## CORRECTIONS AND MODIFICATIONS TO THE DEIS

### FACT SHEET

FIGURE 1-1  
Conceptual Site Layout

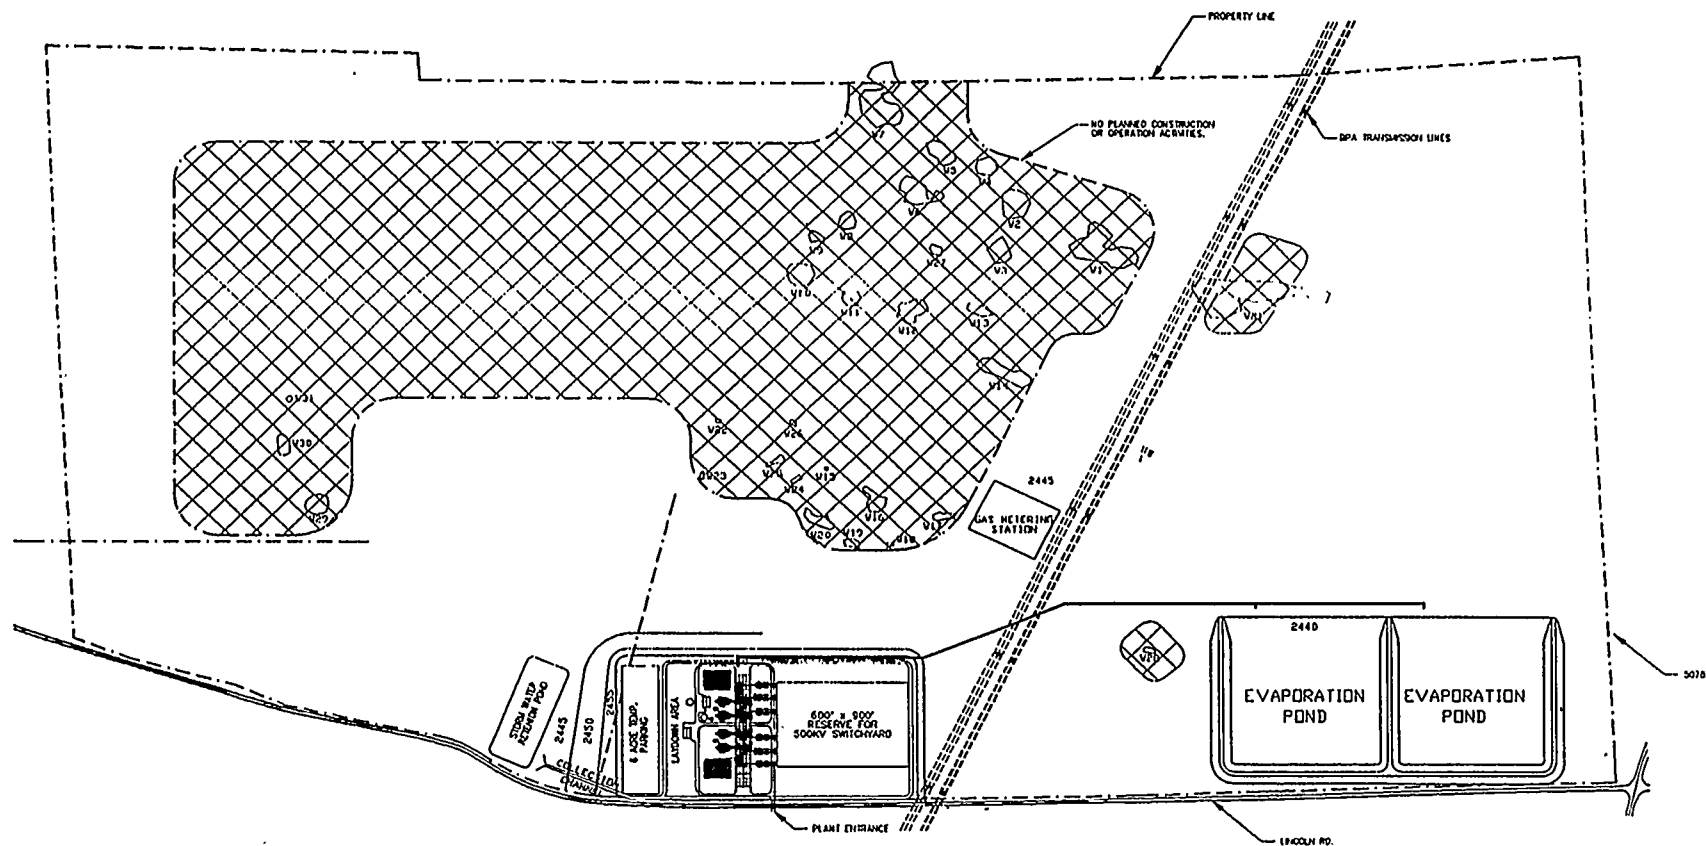
*Page 1-5, Figure 1-1:* See revised Figure 1-1.

FIGURE 2-1  
Site Location Map

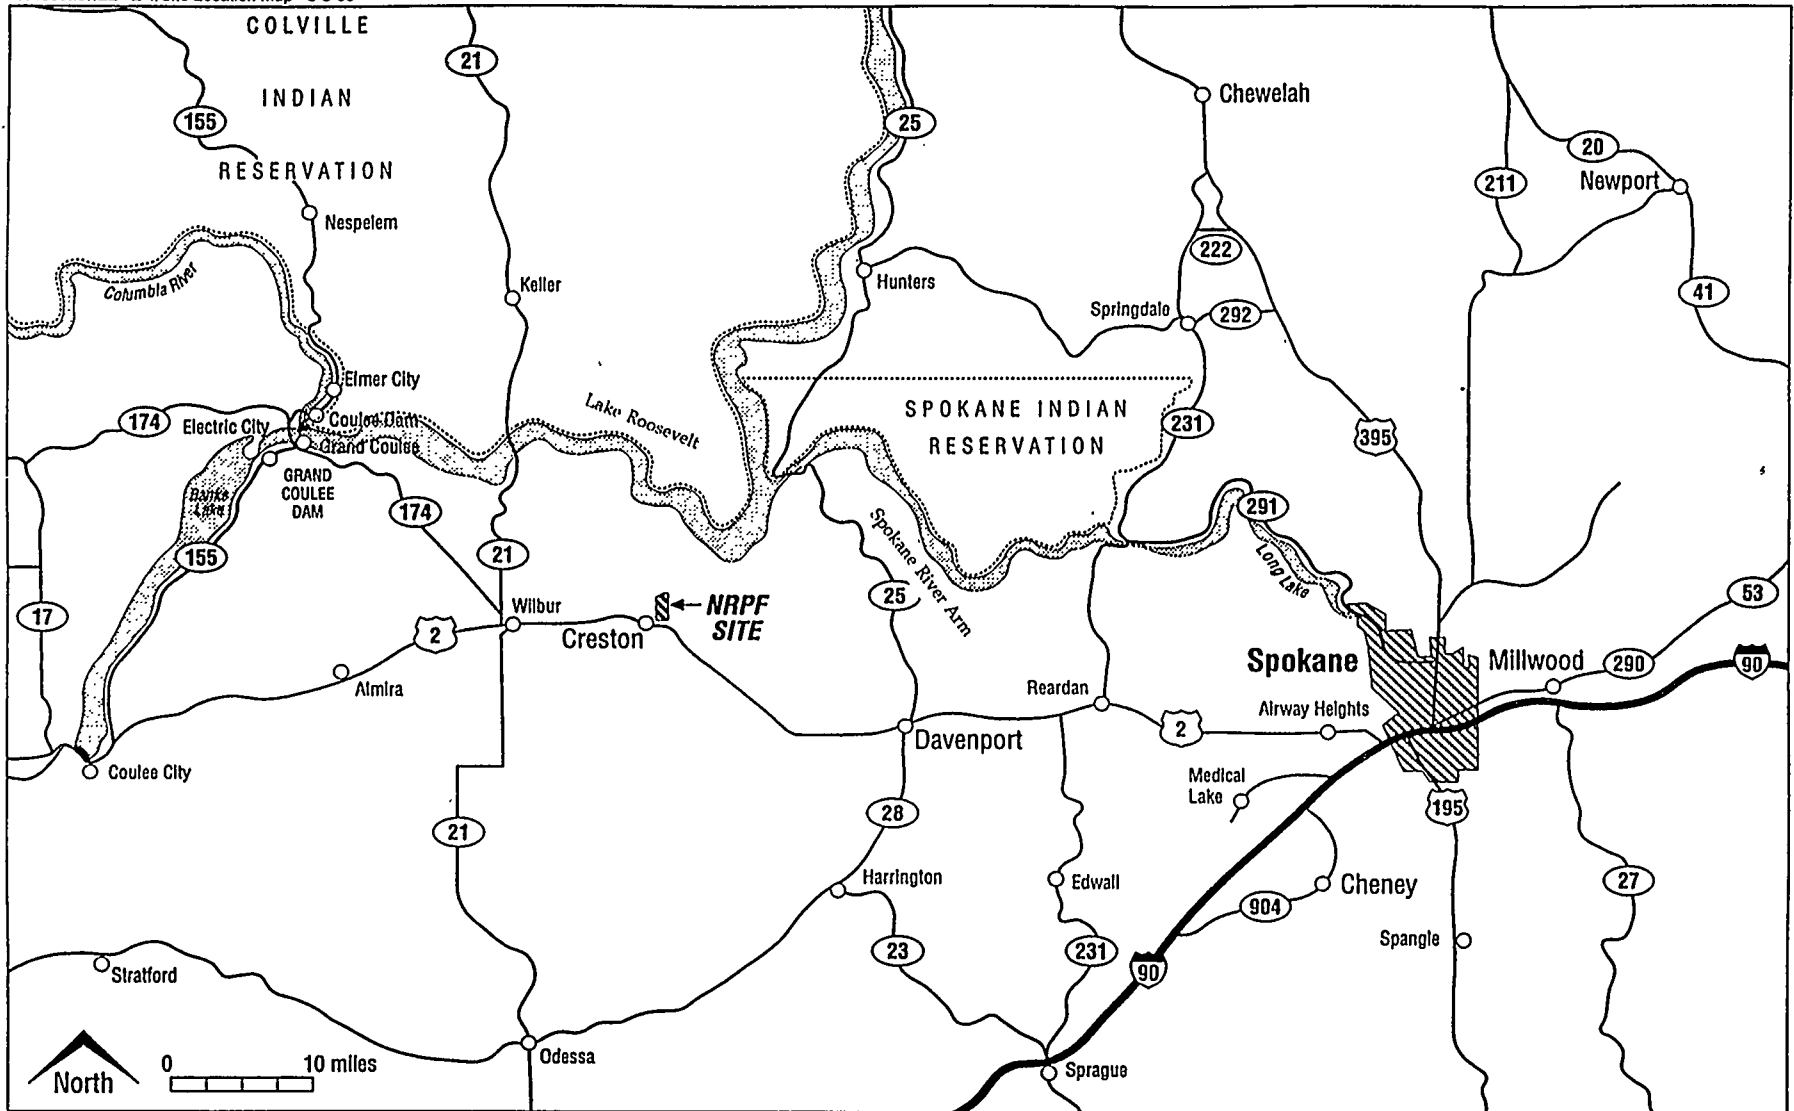
*Page 2-3, Figure 2-1:* See revised Figure 2-1.

FIGURE 2-2  
Conceptual Site Layout

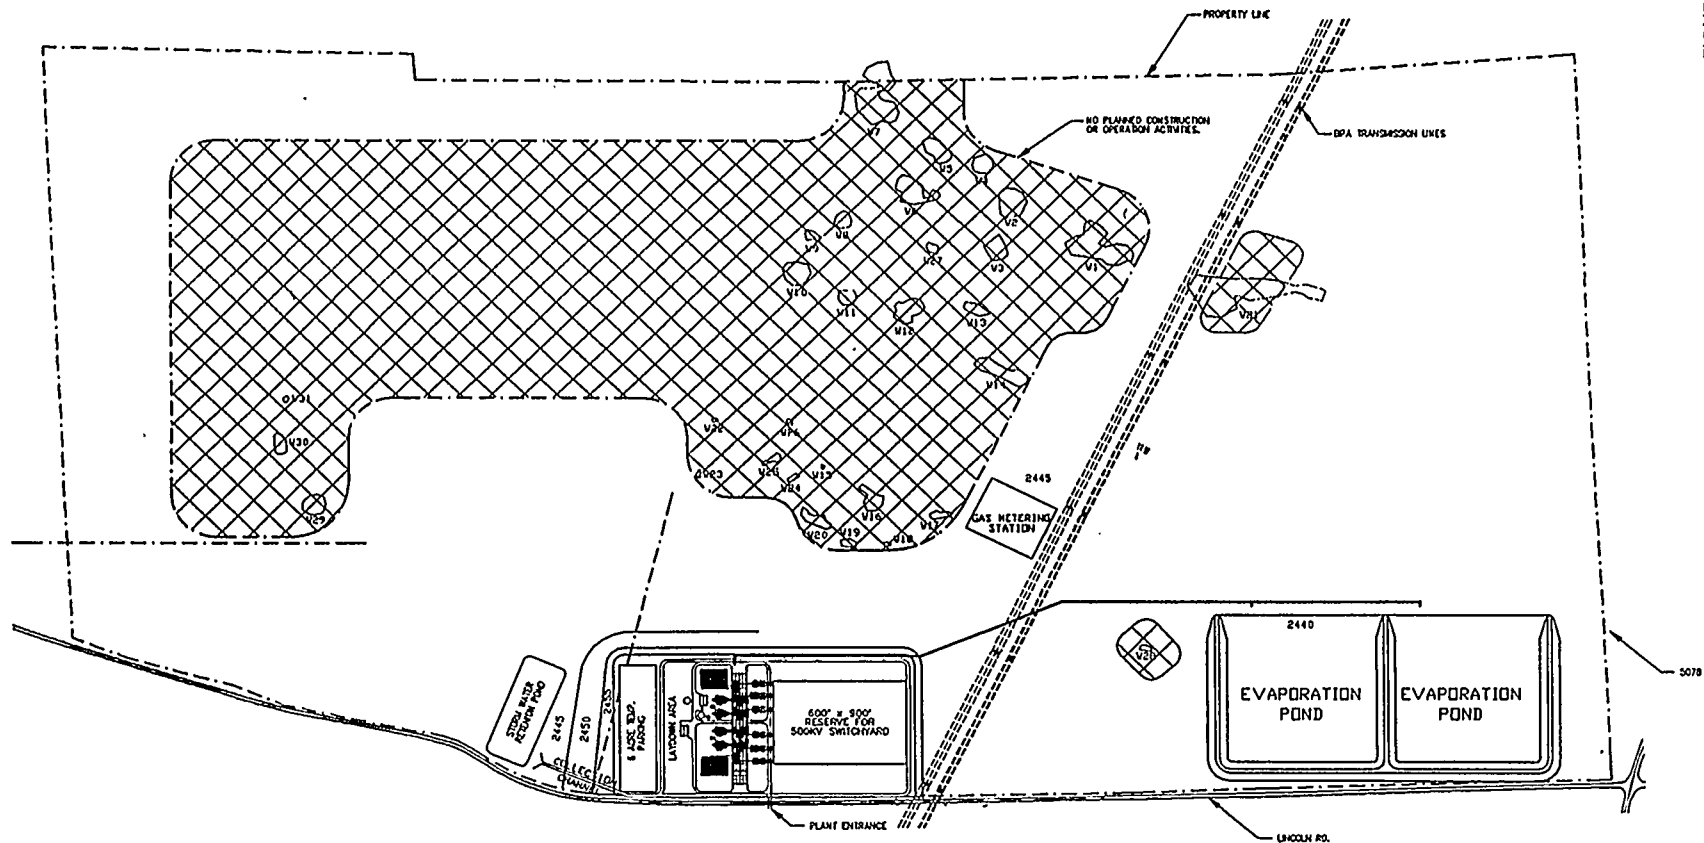
*Page 2-5, Figure 2-2:* See revised Figure 2-2.

FIGURE 2-9  
NRPF Transmission Route  
Map 1: Location Map

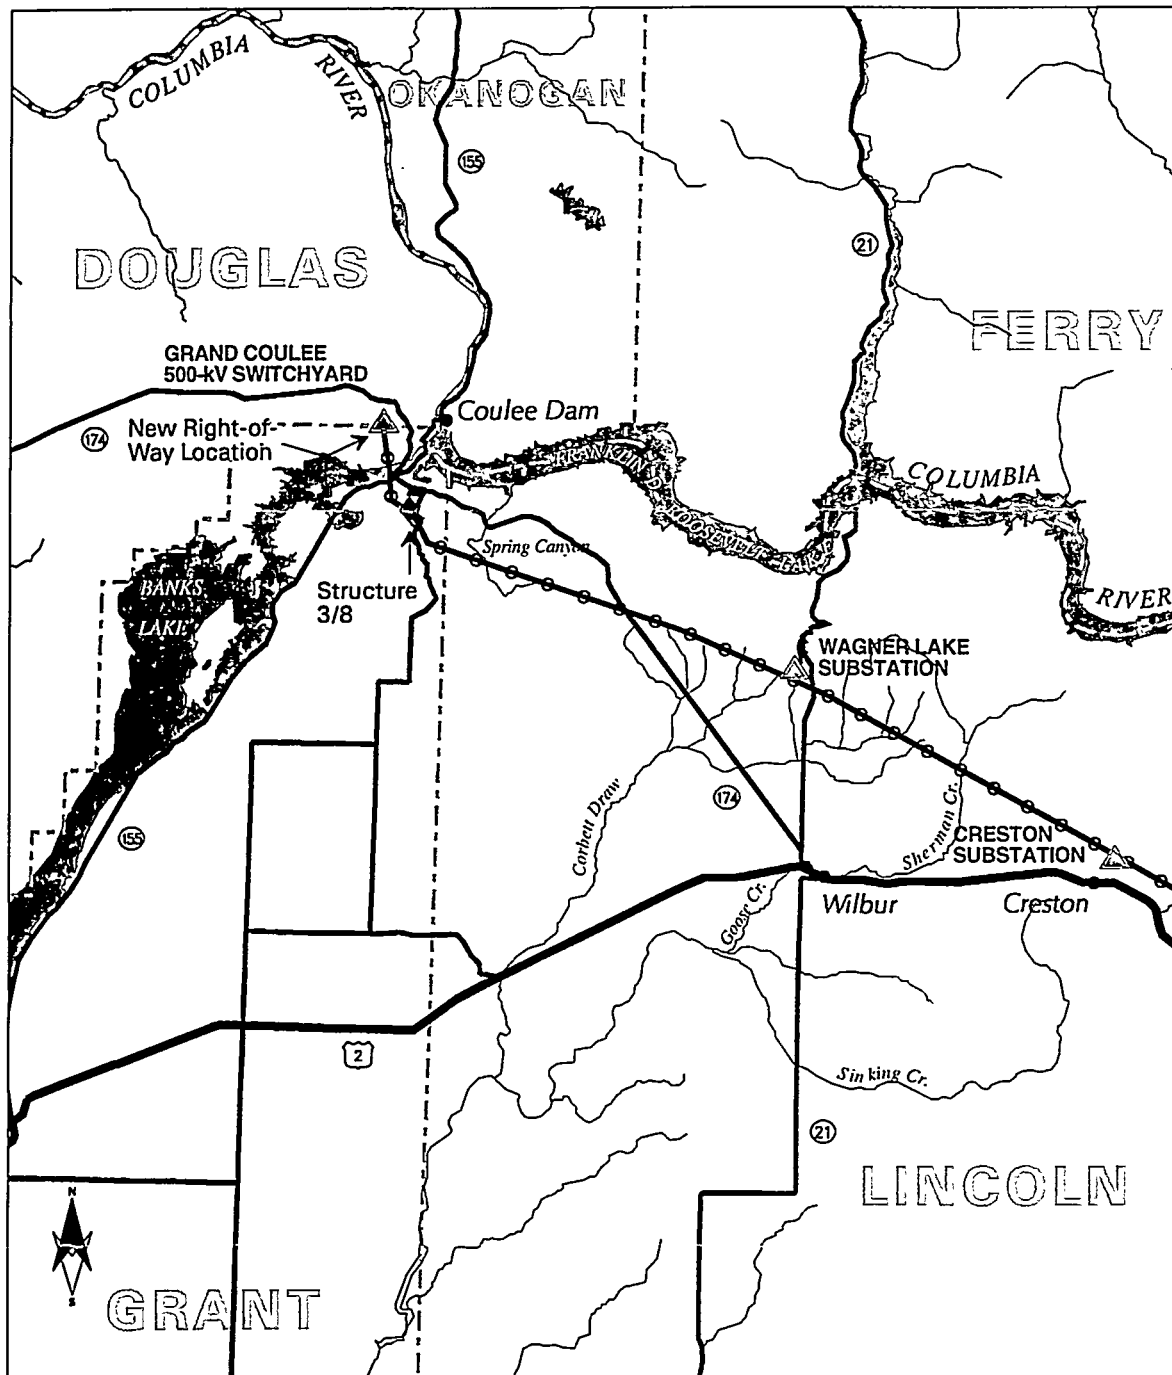
*Page 2-37, Figure 2-9:* See revised Figure 2-9.

NRPF Transmission Route  
Map 2: Major Land Ownership or Designation

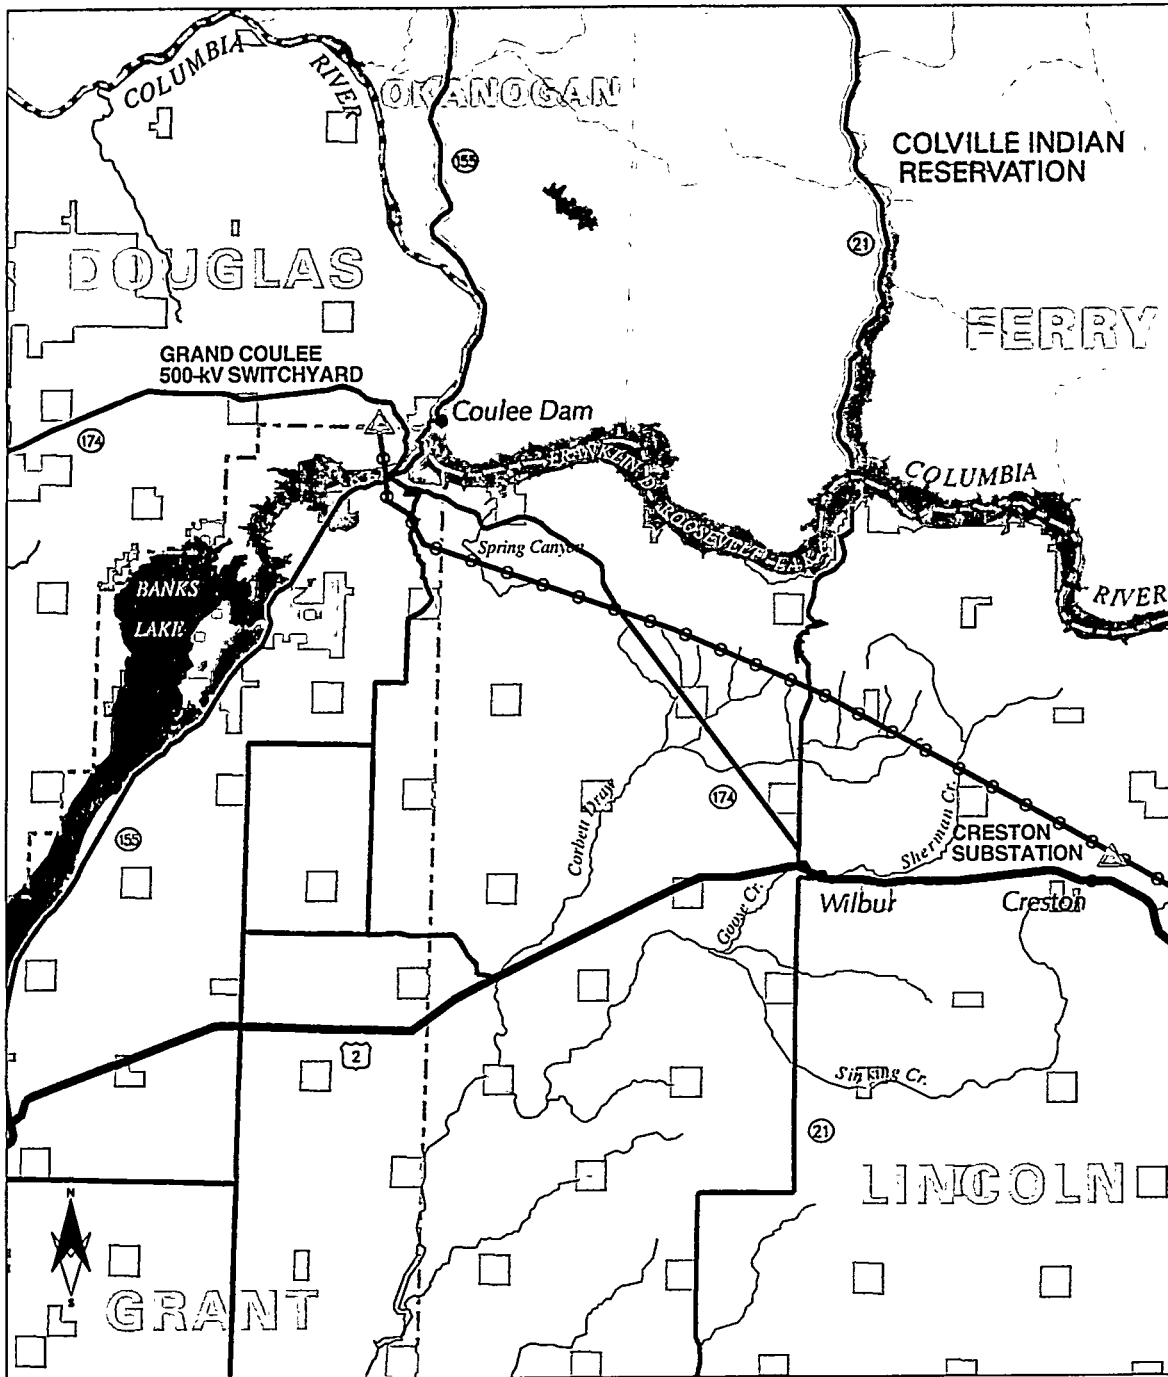
*Page 3-97, Figure 3-9:* See revised Figure 3-9.
